ADDENDUM NO. 1
TO
MILLER ROAD INTERSECTION & CURVE RECONSTRUCTION PROJECT
PHASE 1 STP-5403(680) & PHASE 3 STP-5403(681)
COUNTY OF JEFFERSON, MISSOURI

August 11th, 2021

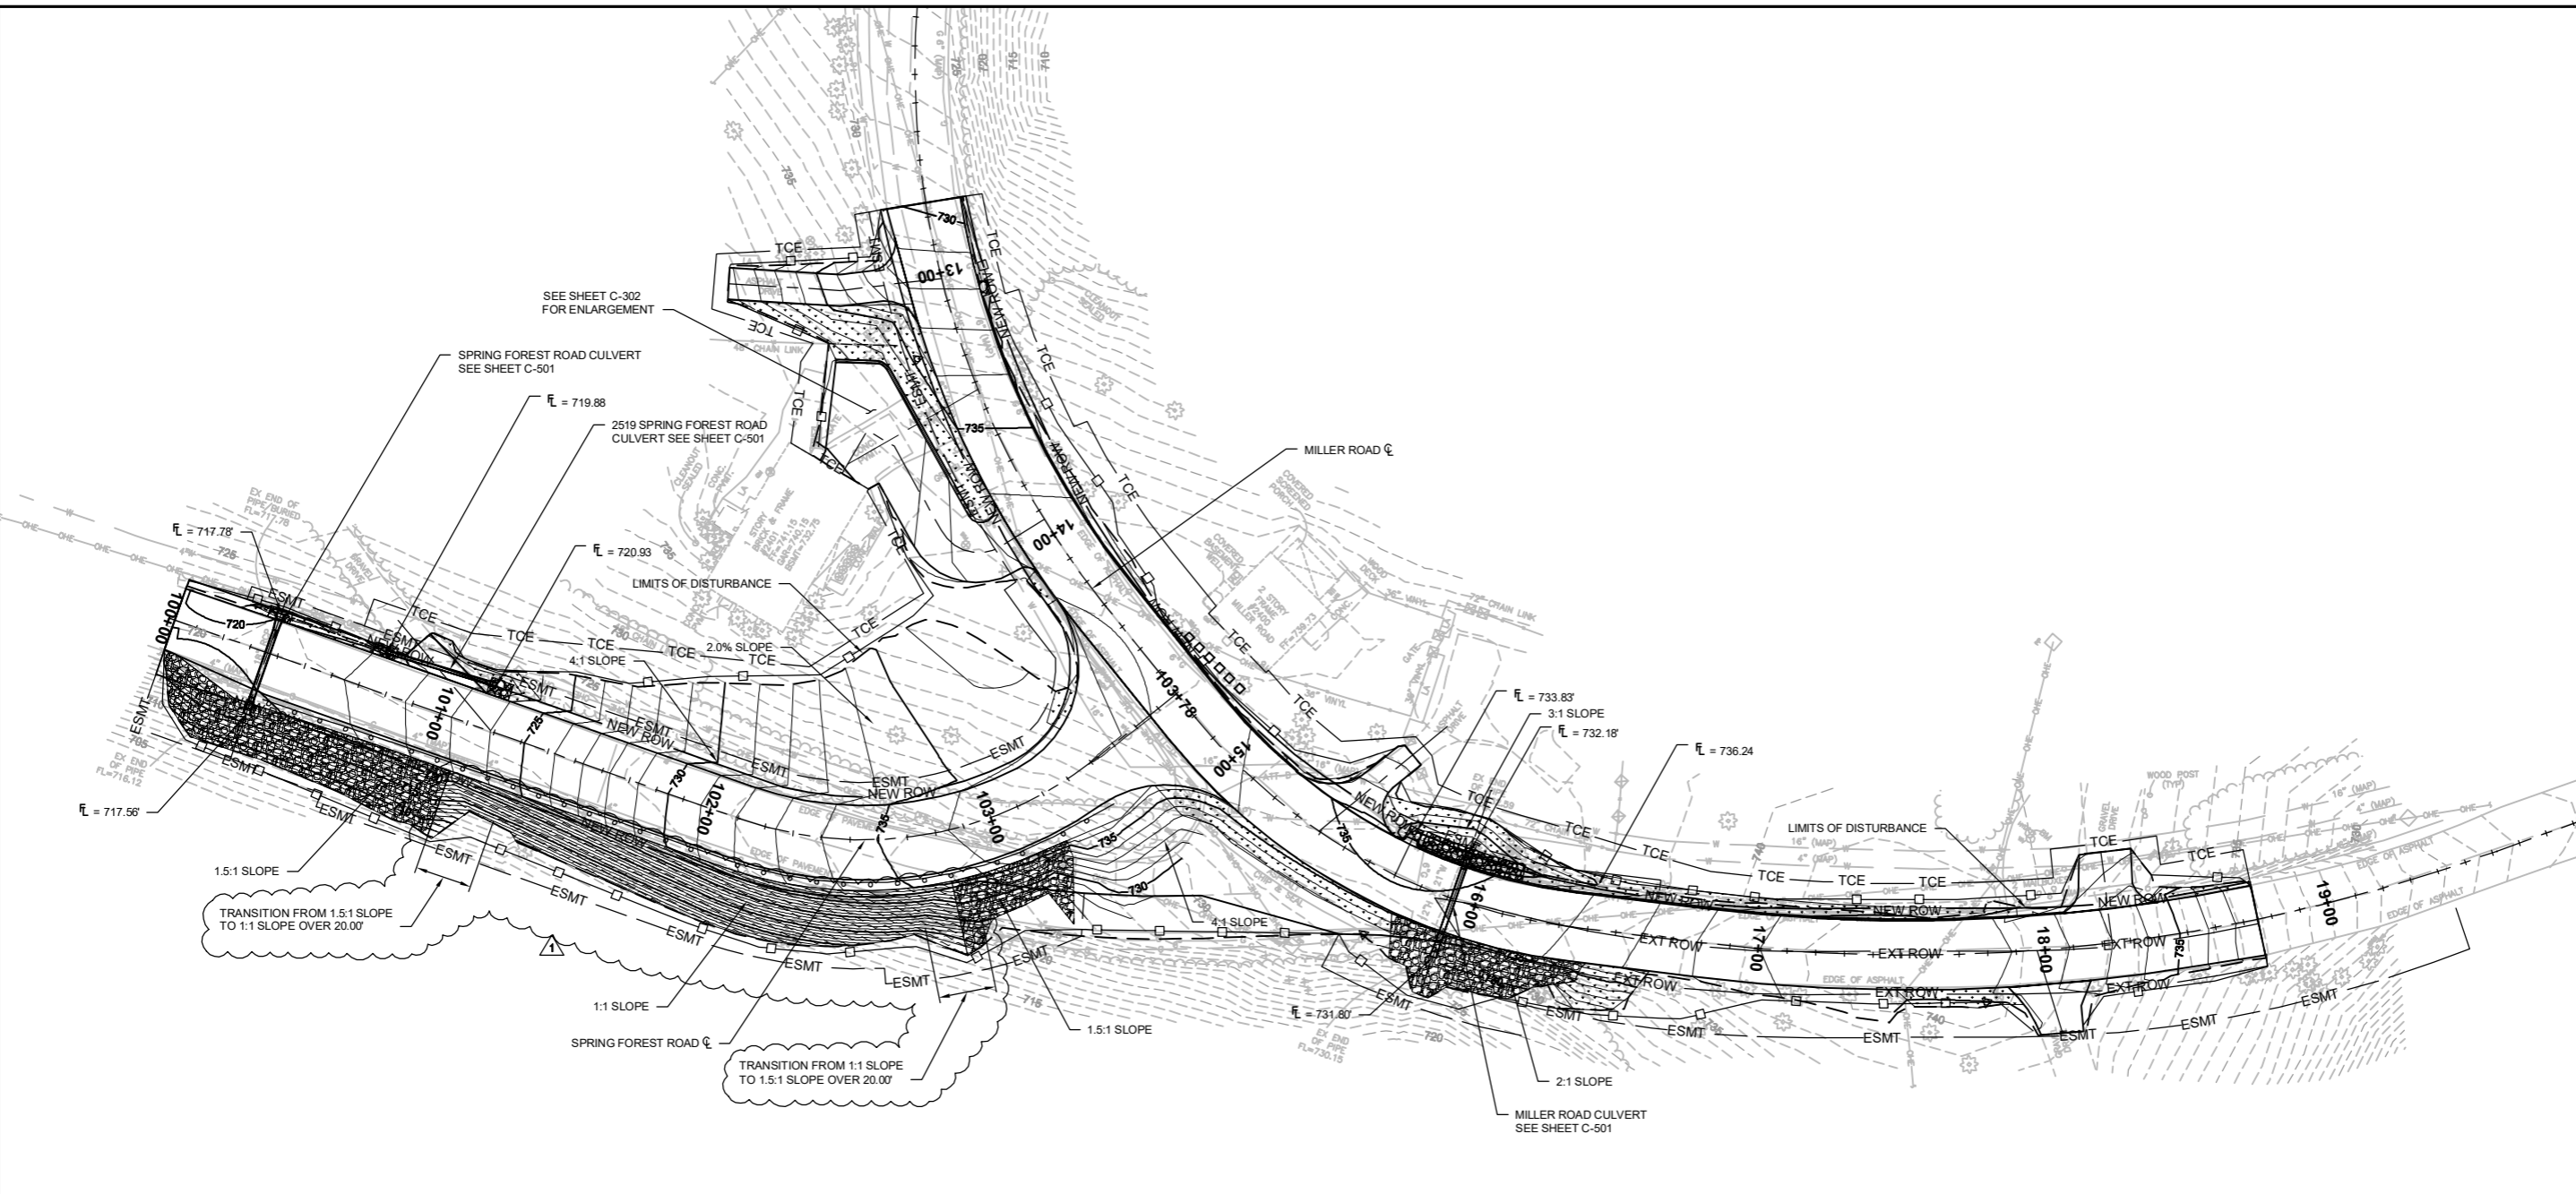
Remove plan sheet C-301 and replace with plans sheet C-301, revised 8/11/21 - 21 – Bid Addendum #1. Reason: the revised plans have the reinforced crushed rock and slope face protection system shown on the plans with the transition from 1:1 slope to 1.5:1 slope over 20'.
Remove plan sheet C-409 and replace with plans sheet C-409, revised 8/11/21 - 21 – Bid Addendum #1. Reason: the revised plans have shown the revised cross-sectional area at STA 100+50.00.

CDG PROJECT NO.
 18101
 DRAWING NO.
 C-410

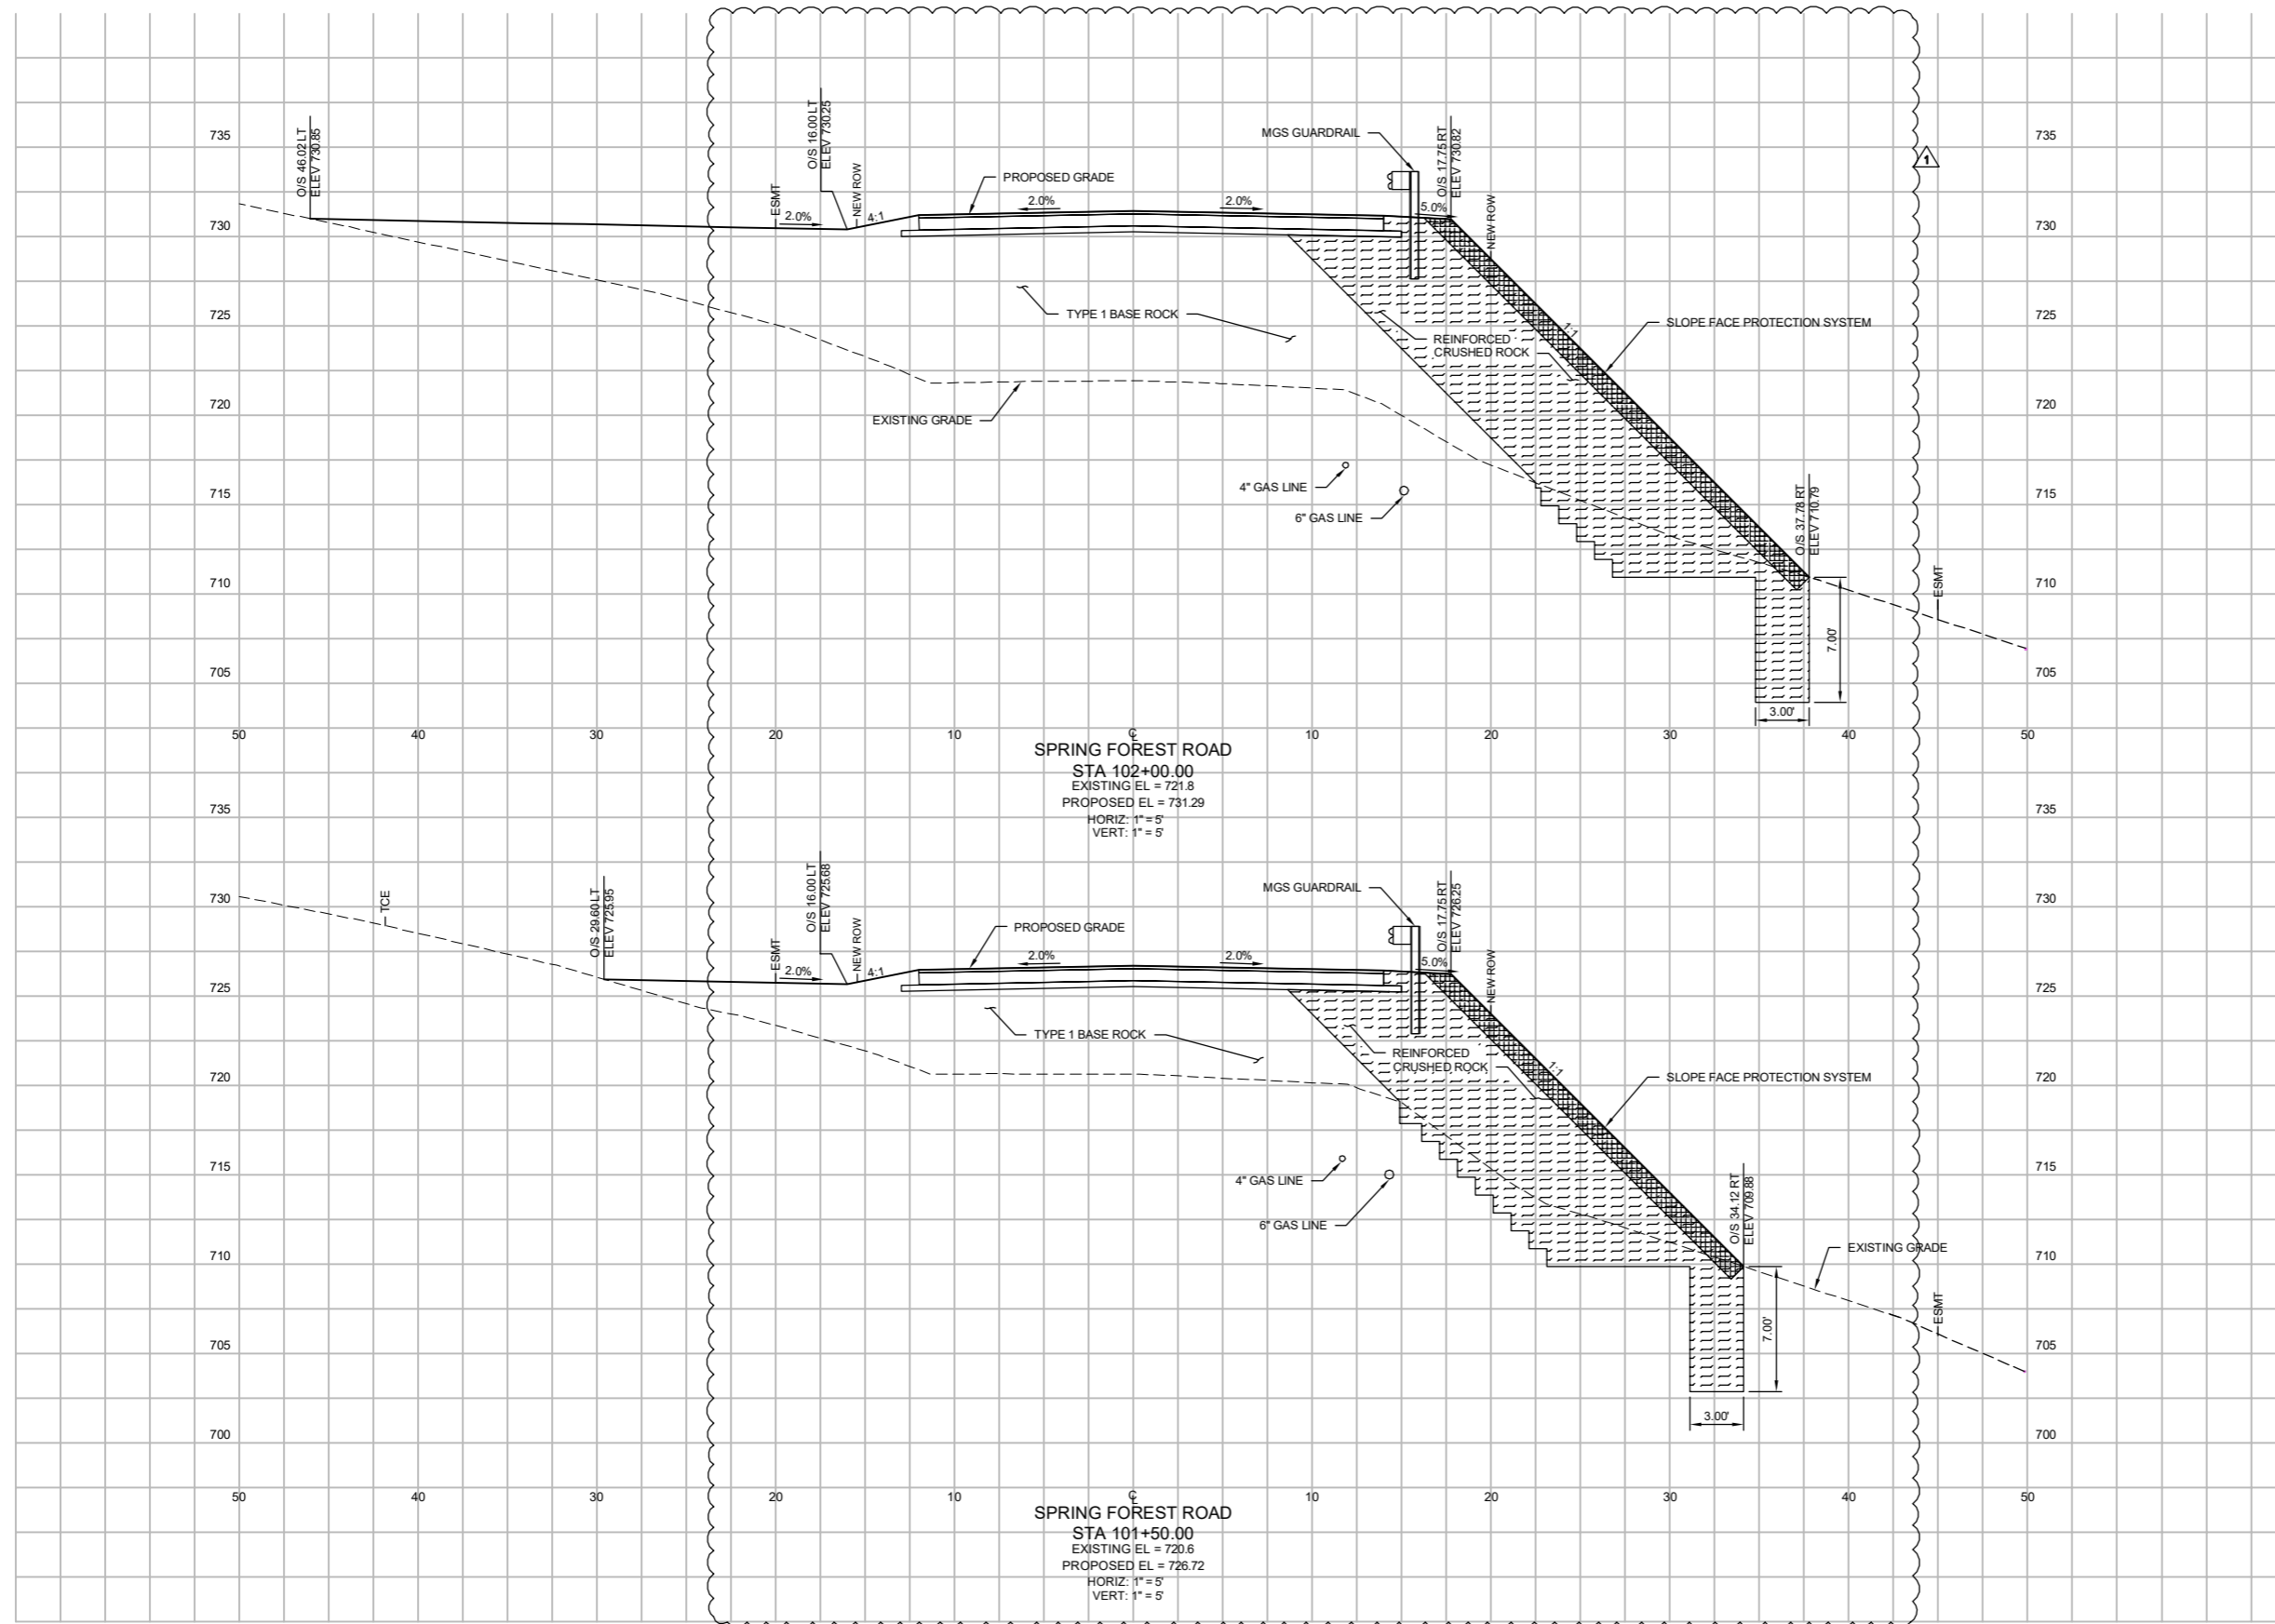
Remove plan sheet C-410 and replace with plans sheet C-410, revised 8/11/21 - 21 – Bid Addendum #1. Reason: the revised plans have shown the revised cross-sectional area at STA 101+00.00.

CDG PROJECT NO.
 18101
 DRAWING NO.
 C-411

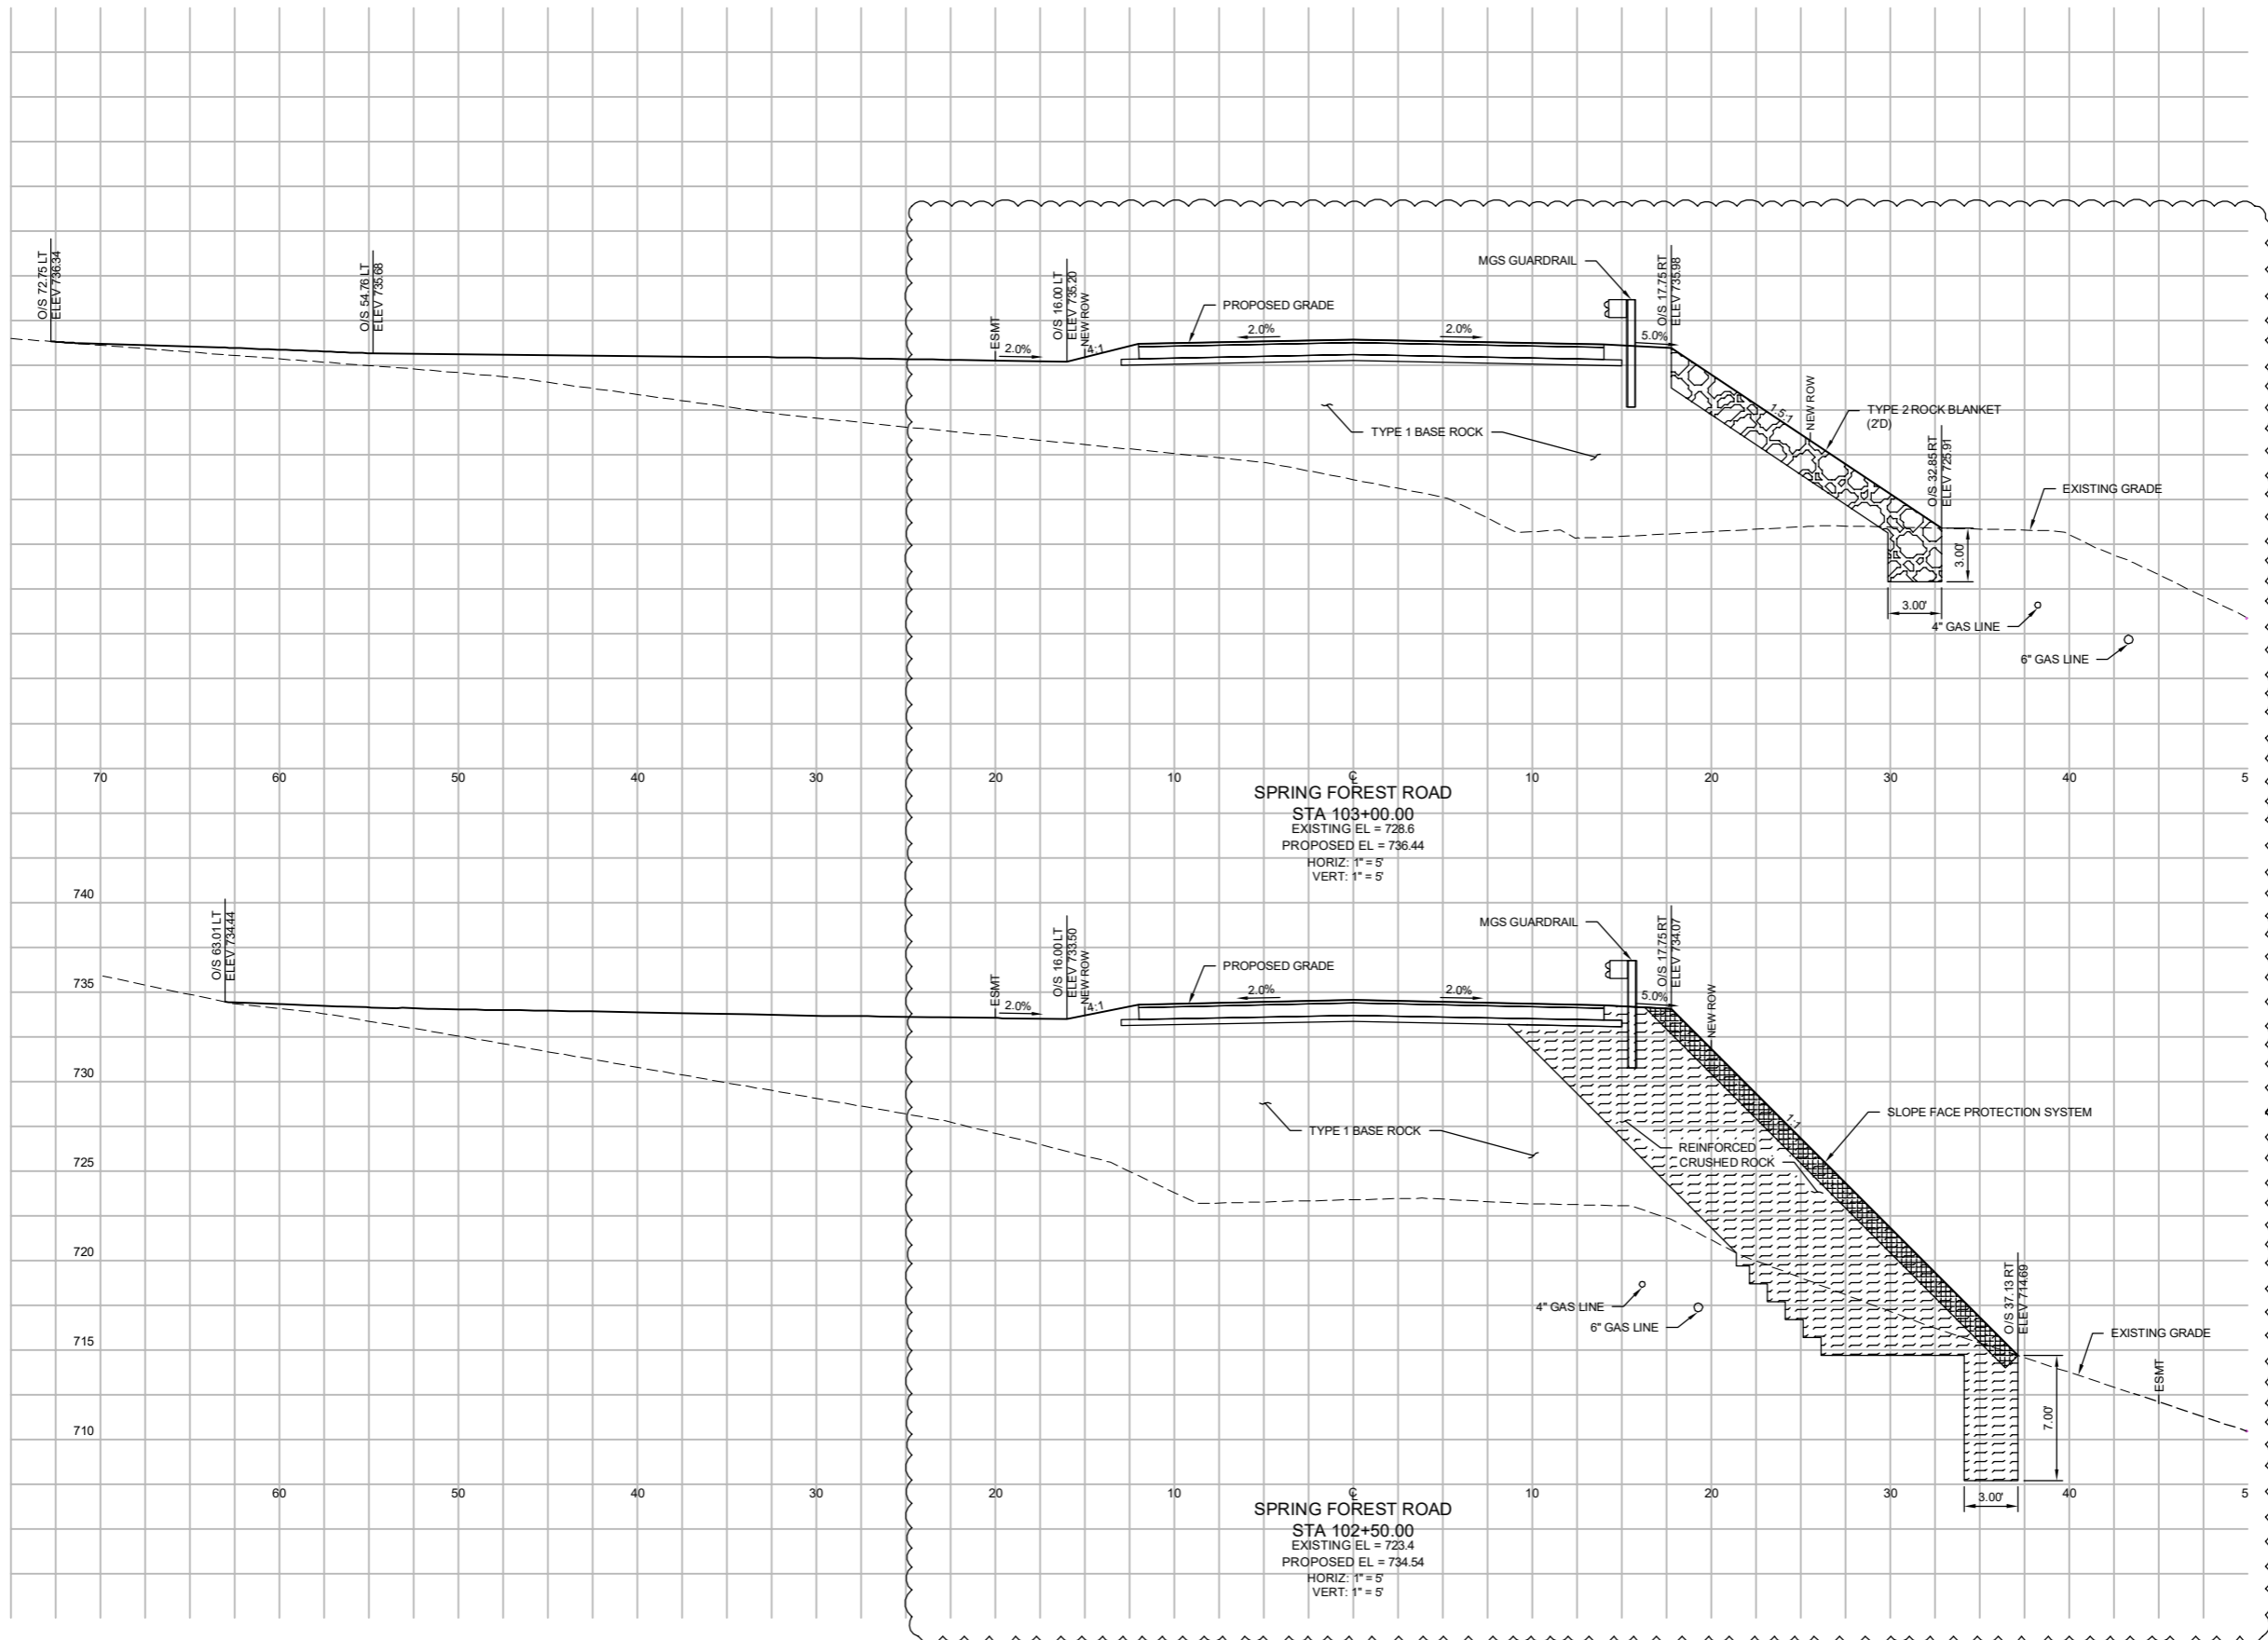
Remove plan sheet C-411 and replace with plans sheet C-411, revised 8/11/21 - 21 – Bid Addendum #1. Reason: the revised plans have shown the revised cross-sectional area at STA 101+50 and STA 102+00 showing the slope face protection system.
